Submission to the Narrabri Gas Project EIS

This is a submission to the Narrabri Gas Project. Application No. SSD 6456

The Wilderness Society
Submission to the Environmental Impact Statement for the
Santos Narrabri Gas Project

Figure 1: Bushfire Risk map in Narrabri Gas Project area, indicates 72% of the project area is classed by the Rural Fire Service as Vegetation Category 1: the Highest Risk of bushfire (Courtesy: RFS and The Wilderness Society).

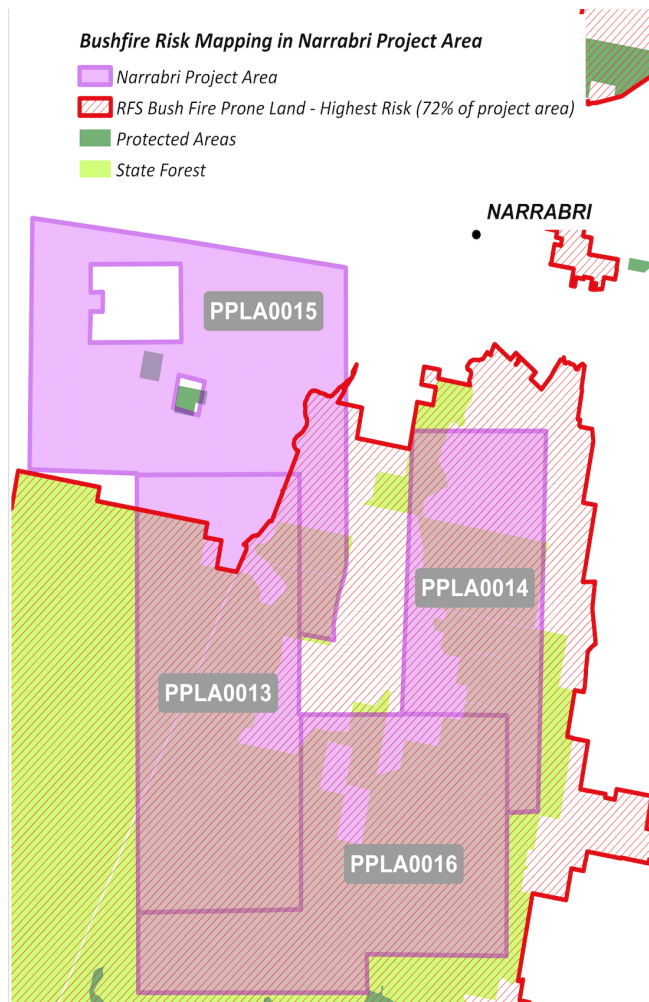
Clearing associated with the development, increased vehicle movements, increased road access and increased weed infiltration all add to bushfire risk. The CSG development will dramatically increase ignition sources as well as extracting, transporting and storing a highly flammable gas (methane) in the project area. Santos does not appear to have a clear bushfire strategy, especially for gas flaring which cannot be shut down on catastrophic fire days.

low intensity hazard reduction burns in these forests in the Pilliga.¹⁸⁴ However, these rates can be much higher in a higher intensity fire in bushfire season. Species such as the koala, pygmy possum, barking owl and microbats would suffer. Figure 1 shows a map sourced from the Rural Fire Service indicating that 72% of the NGP area is categorised as Vegetation Category 1: the “highest risk” of bushfires. Vegetation Category 1 has the highest combustibility and likelihood of forming a fully developed fire, including heavy ember production. This vegetation is dry sclerophyll forest, high fuel loads of up to 20-30 tonnes per hectare.

The EIS recognises the risks to people within the site and outside the forest as a low to remote possibility of injury or consequence, but recognises the need to prepare a Bushfire Management Plan in consultation with the RFS. This should also include NPWS, Local Aboriginal Land Councils, and adjoining landholders. This is not included within the EIS document. Without this document, it is not possible to comment on the validity of Santos’ on fire management assumptions confidently.
